# CITY OF PORTLAND, MAINE

Project Name: Three unit residential condominium building  
Project ID: #2017-227  
Address: 30 Fox Street, Portland CBL: 012 J004001  
Applicant: Dyer Neck Development, LLC  
Planner: Jean Fraser

# PLANNING BOARD REPORT PORTLAND, MAINE

Three unit residential condominium building  
30 Fox Street  
Level III Subdivision and Site Plan  
#2017-227  
CBL: 012 J004001  
Dyer Neck Development LLC, Applicant

**XI. SITE PLAN REVIEW (Section 14-526)**

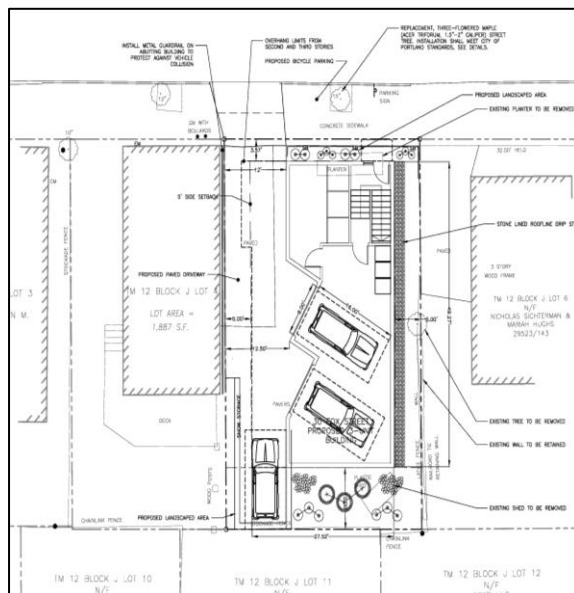
The proposed development has been reviewed by staff for conformance with the relevant review standards of the City of Portland’s site plan ordinance. Staff comments are below.

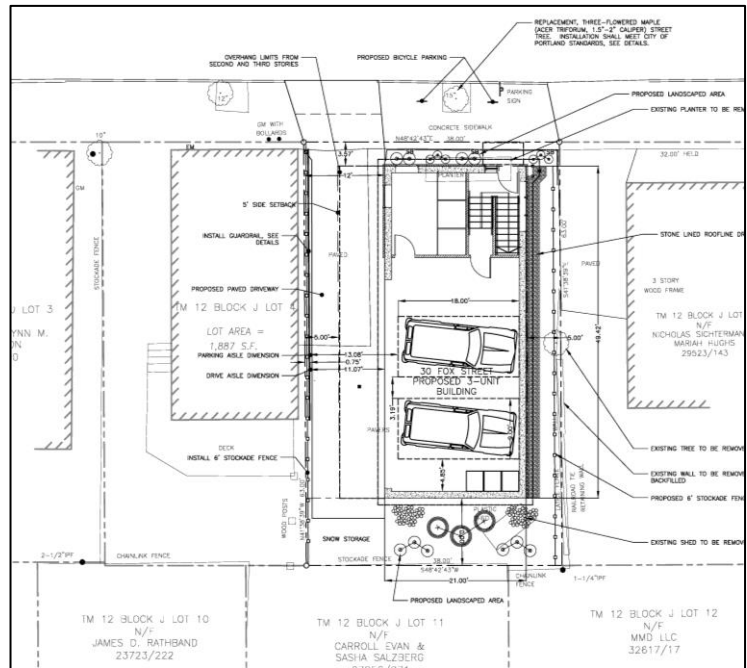
At the Workshop staff comments confirmed that at this location the vehicles must exit the site going forward for safety reasons (Attachments 4 and 8). Neighbors and staff raised a concern over the 11-12 foot width of the parking aisle as originally proposed, when the Technical Standard for perpendicular parking is 24 feet for the parking aisle.

The final layout has been revised as noted below:

- To include full size parking spaces under the building as there is space;
- To reduce the number of parking spaces to two, both under the building;
- Remove the garage doors and supporting column between the doors to create an open parking and maneuvering area;
- Provide a turning area at the end of the drive access so that vehicles can exit going forward;
- The parking aisle has been increased to 13 feet, with a waiver requested in respect of the Technical Standard.

The development of this final proposal has involved extensive revisions based on field simulations (most observed by reviewers who also checked the dimensions as marked on the site - videos are attached at *Plan P17*) of vehicles maneuvering into and out of the parking area based on various parking area dimensions. Several earlier designs were not supported by the Traffic Engineering reviewer Mr Errico, but this final layout and the associated waiver is supported by Mr Errico (Attachment 8) as quoted below:

*the building column constrained turn movements. During initial conversations with the Applicant several months ago, I inquired about the need for the building support and noted that it was a major constraint to vehicle circulation. The review of vehicle circulation with the building column, while was feasible with mid-size vehicles, was not a condition that I could support. The elimination of the column eliminates a significant constraint and provides added flexibility on how to maneuver into and out of the garage. That changed my conclusion, from a situation where vehicle circulation to avoid backing into Fox Street was feasible but likely to lead to some unsafe movements to one where vehicle circulation can reasonably occur, thus avoiding a backing situation.*
